APPEAL SUMMARY

Appeal ID: 24537	Project Address: 546 NE 12th Ave
Hearing Date: 1/20/21	Appellant Name: Joe Echeverri
Case No.: B-009	Appellant Phone: 9714201120
Appeal Type: Building	Plans Examiner/Inspector: John Cooley, Nate Takara
Project Type: commercial	Stories: 2 Occupancy: A-1, A-2, A-3, A-4, B, E Construction Type: II-B, III-B, II-A
Building/Business Name: Benson Polytechnic High School	Fire Sprinklers: Yes - NFPA 13 throughout
Appeal Involves: Erection of a new structure, Alteration of an existing structure, Reconsideration of appeal	LUR or Permit Application No.:
Plan Submitted Option: pdf [File 1] [File 2]	Proposed use: High School

Portland Public Schools
**BENSON
POLYTECHNIC
HIGH SCHOOL
MODERNIZATION**

546 NE 12th Ave, Portland, OR 97232

EX L0

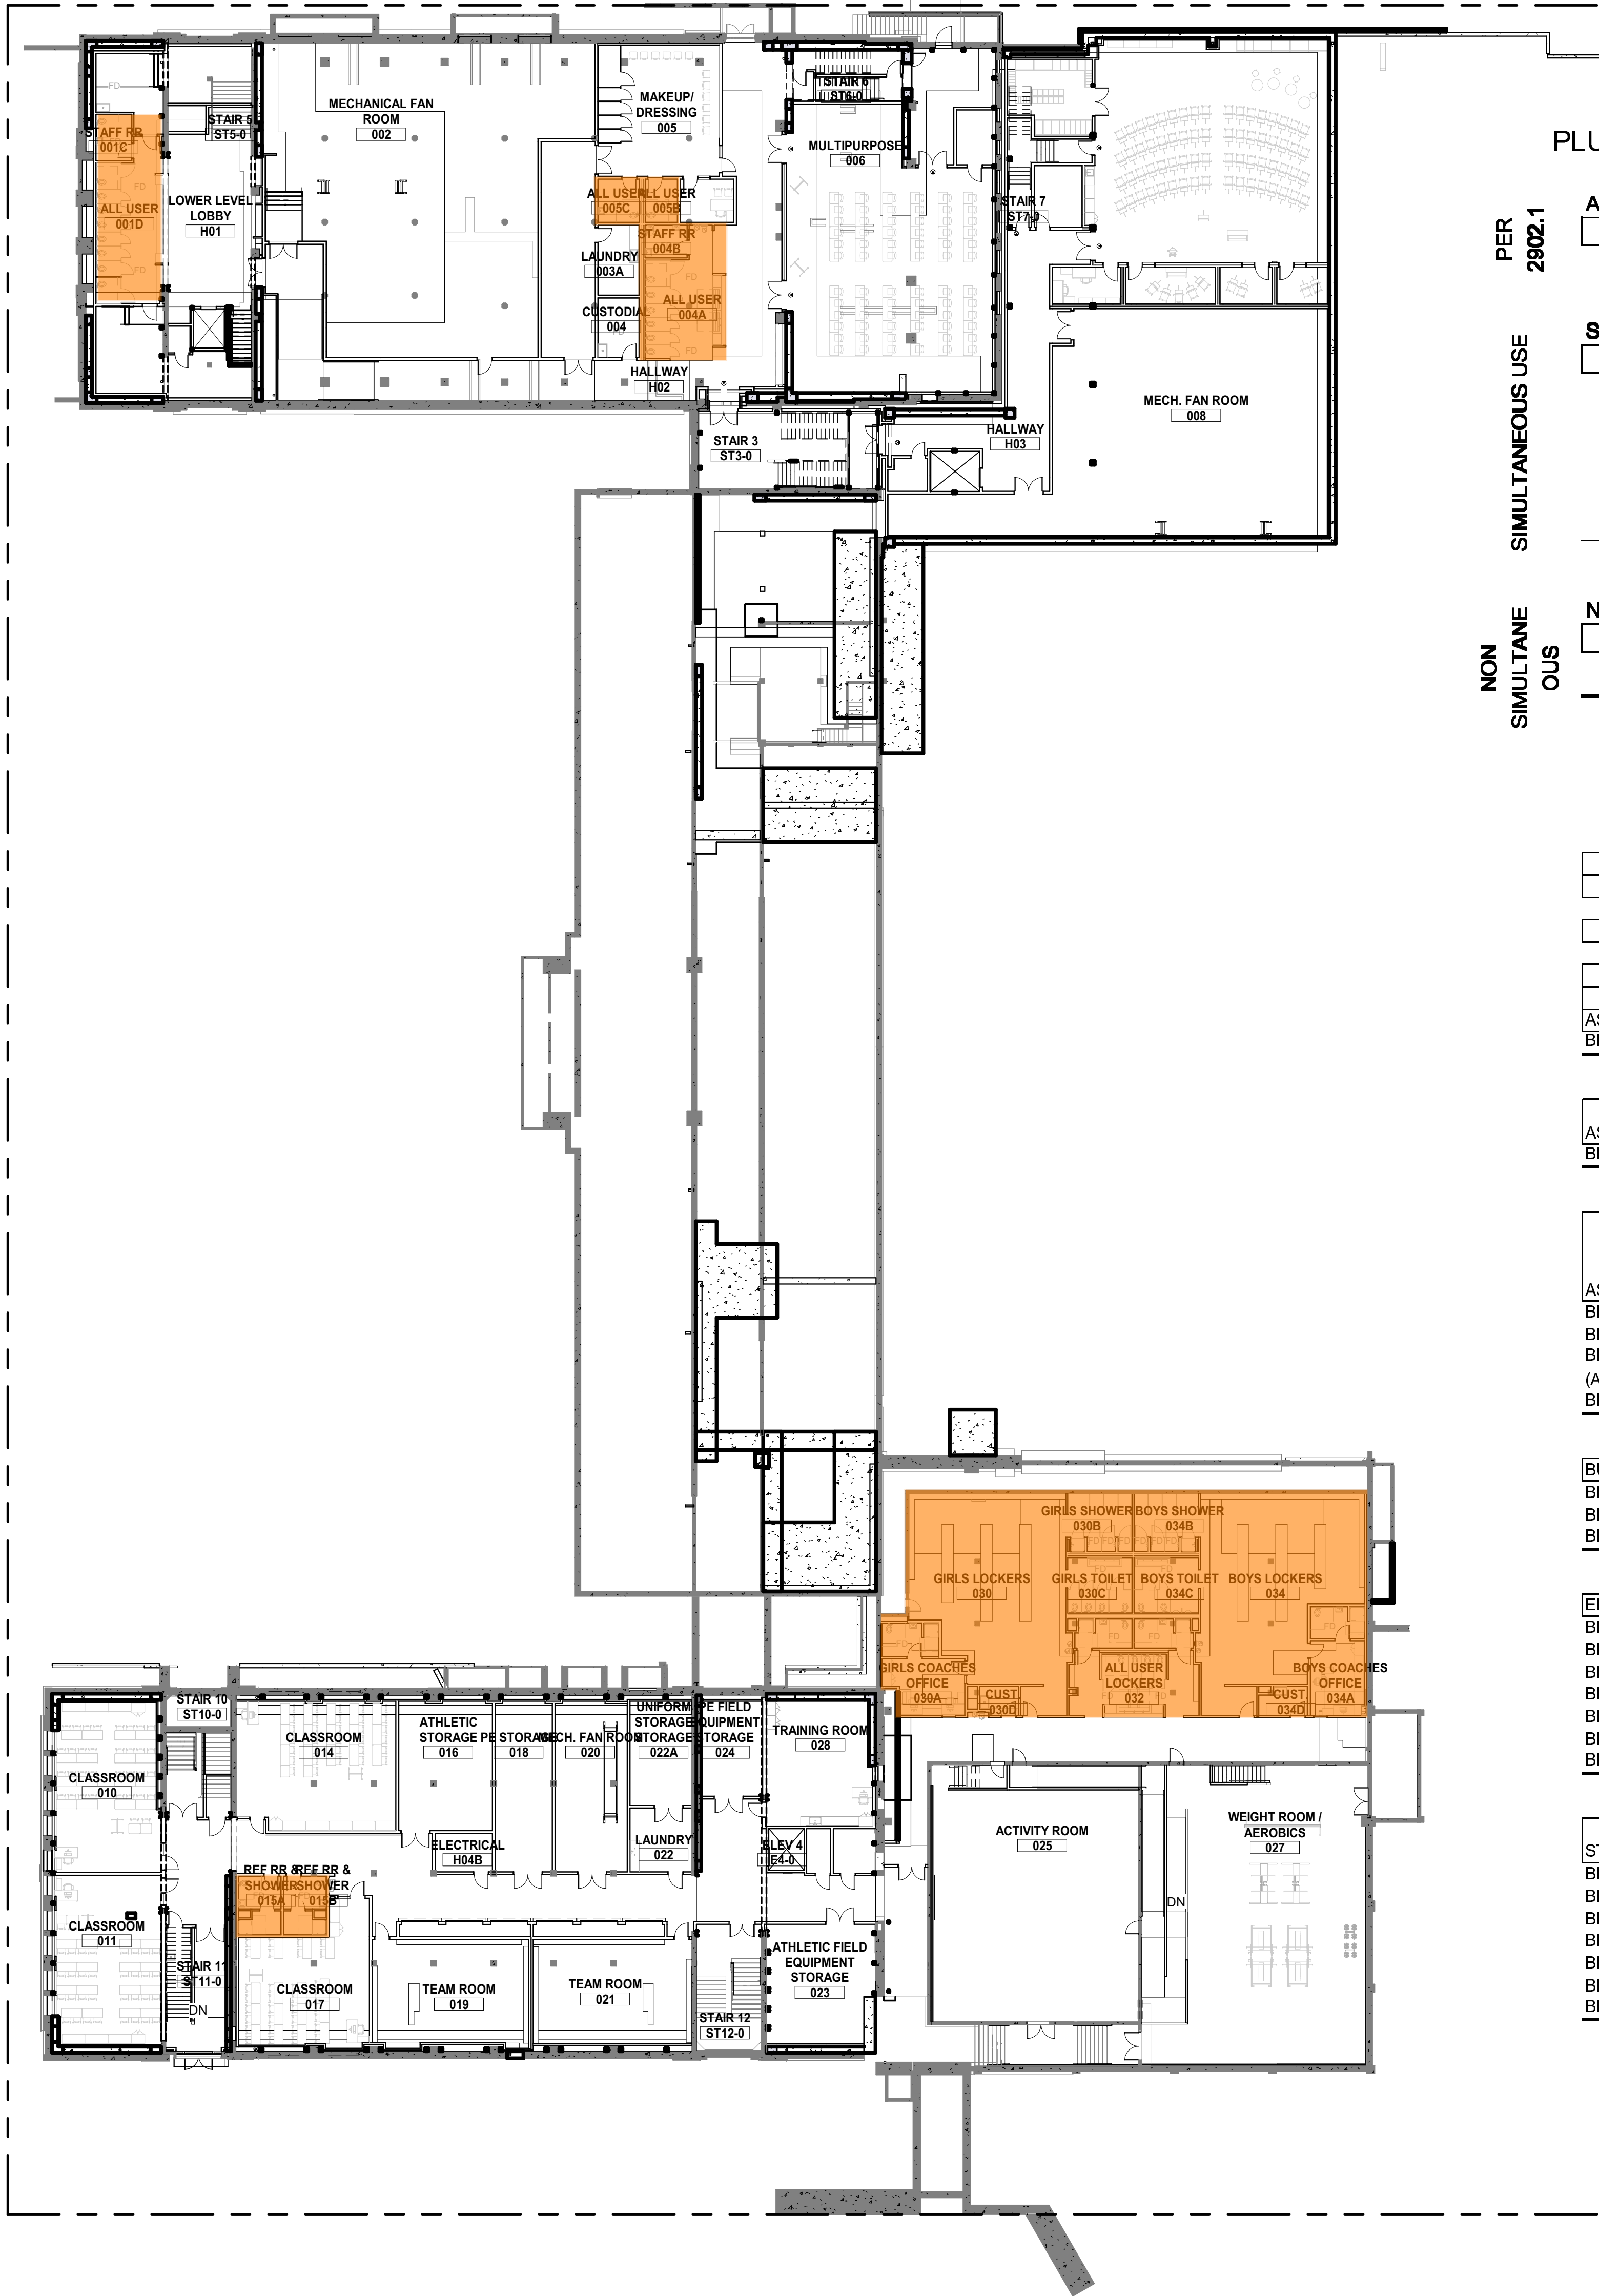
Code Section	2901.2, 2902
Requires	Building official may take any action modifying a Chapter 29 requirement or accepting an alternate method. Plumbing fixtures shall be provided in the minimum number as shown in Table 2902.1 based on actual use of the building or space.
Code Modification or Alternate Requested	Reduce number of minimum required plumbing fixtures. Calculate number of required fixtures based upon non-simultaneous use of space.
Proposed Design	<p>Design provides plumbing fixtures for 1800 high school students and staff per the Portland Public Schools (PPS) design specification. The proposed number of fixtures is less than the required minimum number of fixtures calculated per Table 2902.1 when the rooms are occupied simultaneously.</p> <p>Required fixtures: Total 200 WCs, 157 LAVS Design proposes: Total 140 WCs, 109 LAVS</p> <p>On an average school day, 1800 students and staff are expected. The school provides spaces for student use that are not occupied at the same time as they occupy school classrooms and staff offices. Design proposes that the Auditorium and Gymnasium; Media Center and Common areas be deducted from the total required since these spaces will not be fully occupied and in use at the same time.</p> <p>See exhibit for plumbing facilities and areas of simultaneous use.</p> <p>RECONSIDERATION: Added the Plumbing Fixtures Required per Table 2902, Exhibit page L0. This shows the occupancy use group with total 6400+/- occupant load when calculated per OSSC 1004.5.</p>

RECONSIDERATION: Exhibit page L0 updated per discussion with plans examiner John Cooley. Exhibit includes use and associated occupant load as calculated per OSSC 1004.5. The result of calculations requires fixtures to be provided for 6400 occupants with an allowable reduction for fixed theater seats or bleachers. This occupant load and fixtures significantly exceeds the occupant load for school during the school day and for after-hours use.

- 1. Reduction in minimum number of required plumbing fixtures: Granted as proposed.**
- 2. Existing handrail conditions to remain: Granted as proposed.**
- 3. Existing exit access stair configurations to remain with addition of quick response sprinkler heads: Granted as proposed.**
Note: Appeal also grants interior exit stairs 10 and 12 with quick response sprinkler protection on both sides of glazed walls. A separate permit from the Fire Marshal's Office is required.
- 4. Use of rail mounted ADA inclined platform stair lift for accessible route to two Level 2 classrooms at West side of Gymnasium: Granted as proposed with reduced stair width while lift is in operation.**
- 5. Omission of barrier where stairs continue below level of exit discharge: Granted as proposed.**
- 6. Allow existing historic guard rail heights to remain as built: Granted as proposed.**

SK 1c

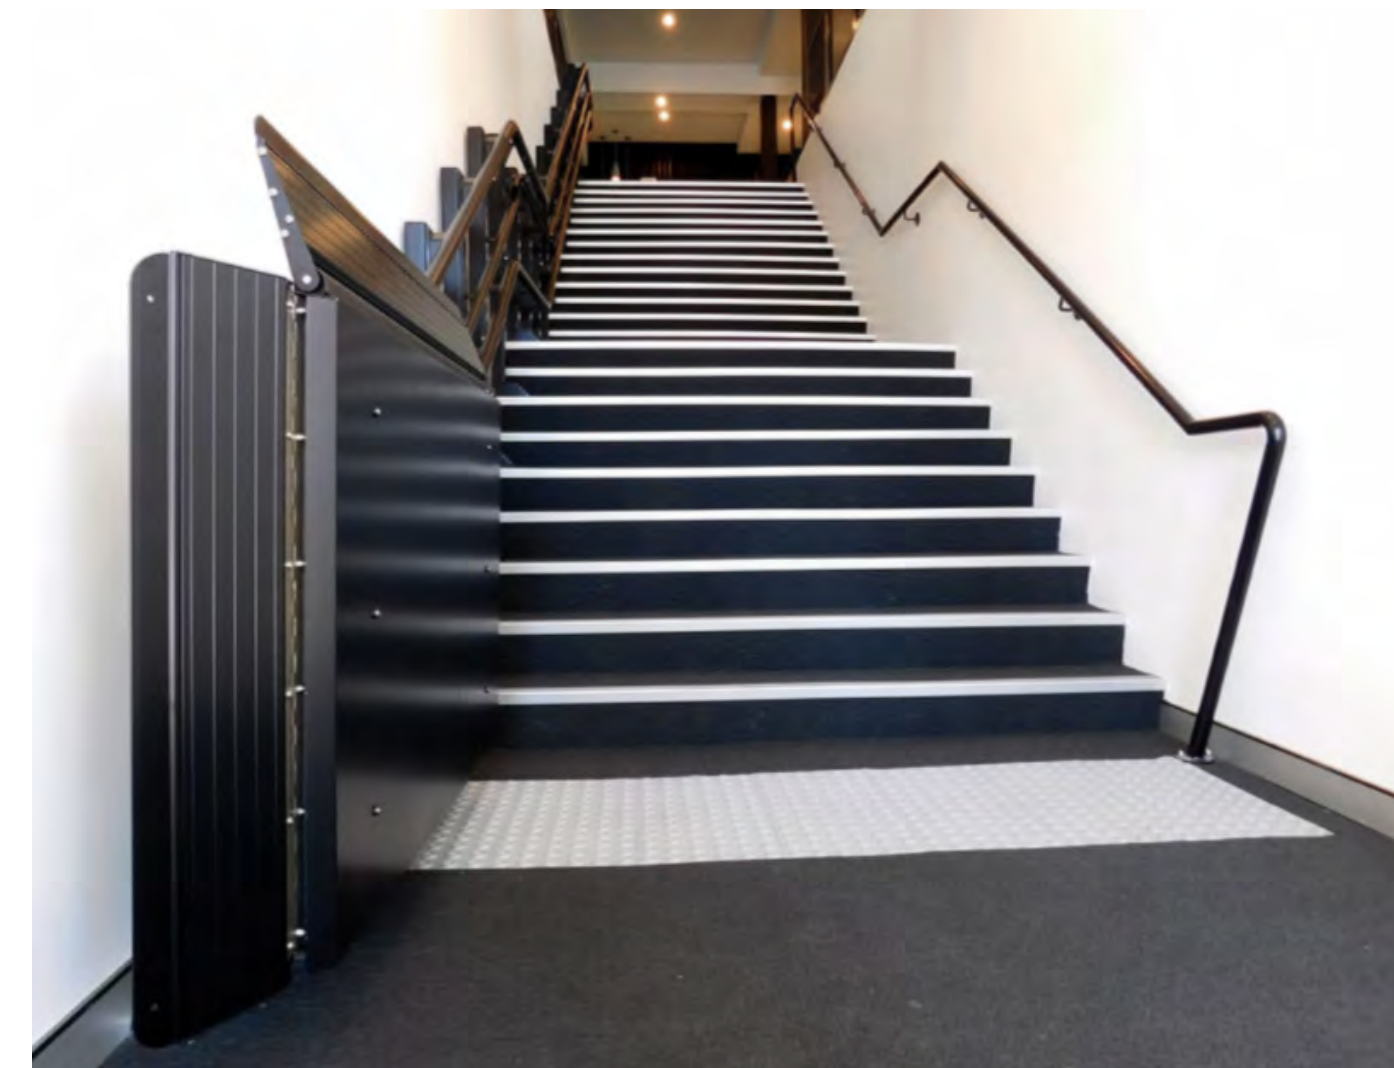
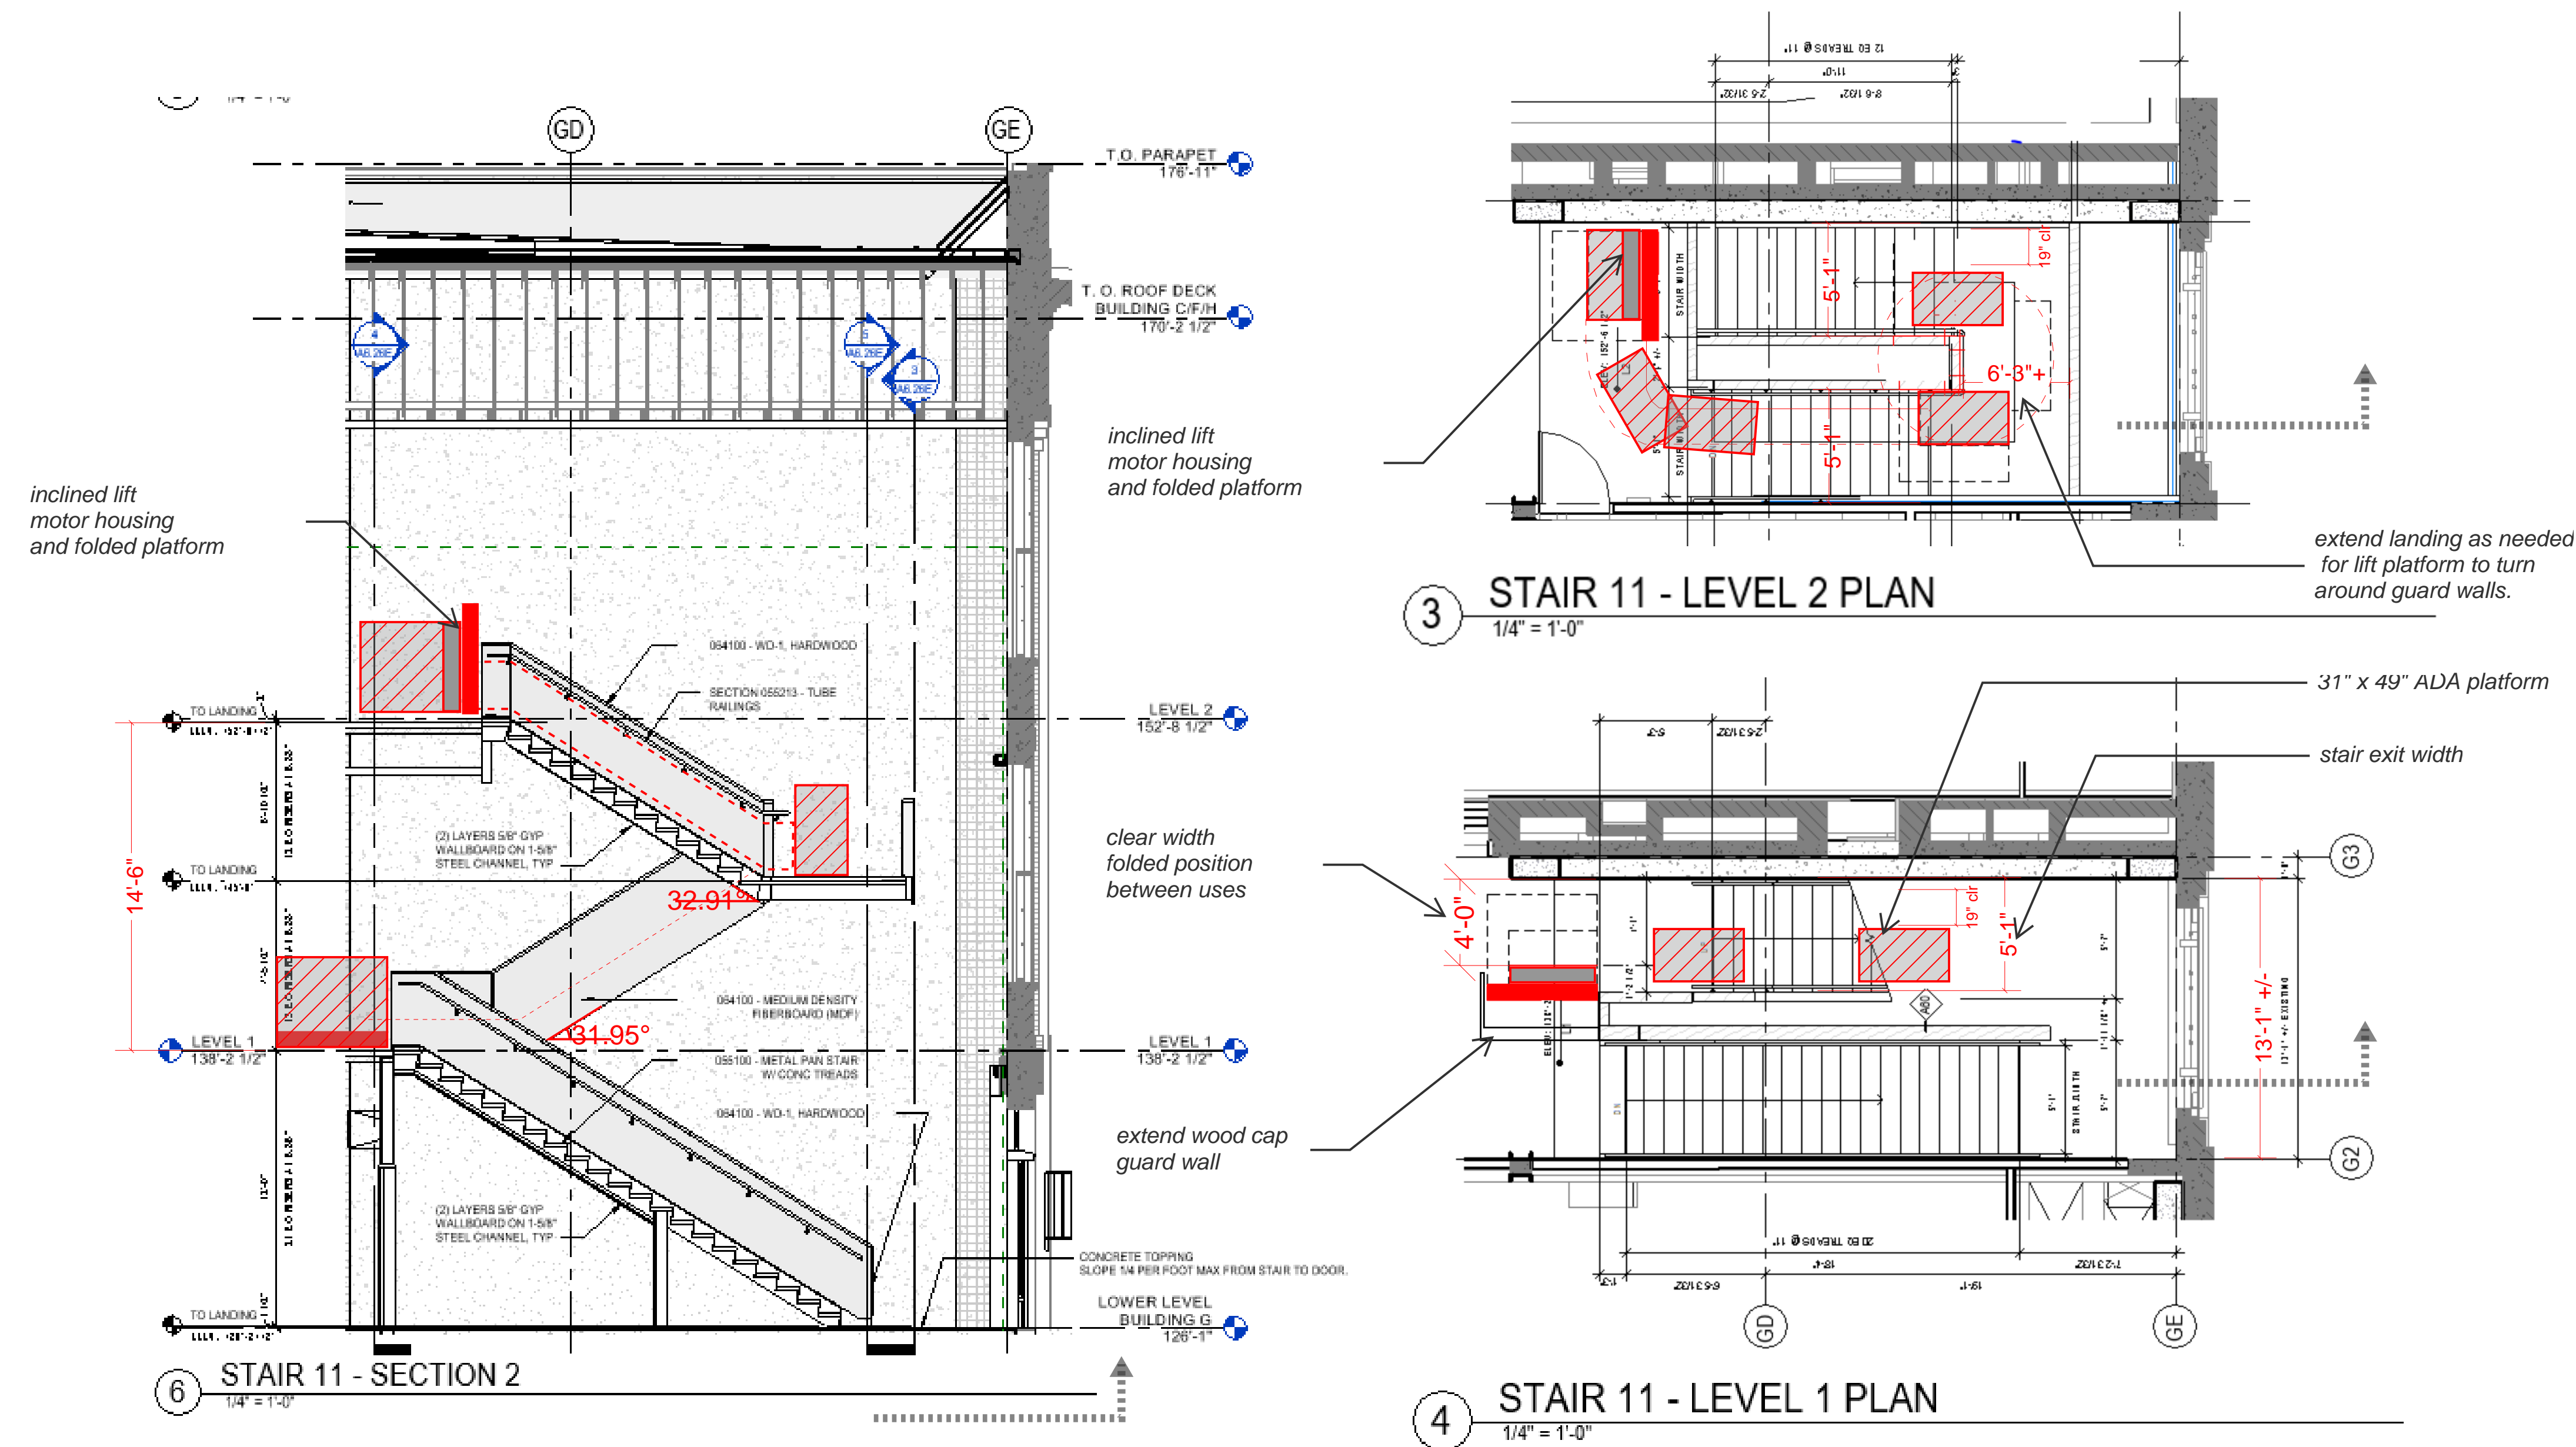
Propose to provide rail mounted ADA inclined platform stair lift at Gymnasium exit access Stair 11 for accessible access between Levels 1 and 2 west side of Gymnasium. Inclined platform lift shall be designed and installed in conformance with Oregon State Elevator code as required for inclined platform lifts.

Stair 11 width is 5'-0" wide. When platform in use, the platform and guide rails occupy 41" leaving 17-19" inches of clear width between moving platform and handrail. Since platform is not intended for emergency exit use, no emergency power supply will be provided.

When not in use, the platform will rest at Level 2 beside the stair and beyond the travel path. Two way communication call station and signage shall be located adjacent to platform at Level 2 and at Level 1 landing.

See SK1c for Stair plan with equipment layout.
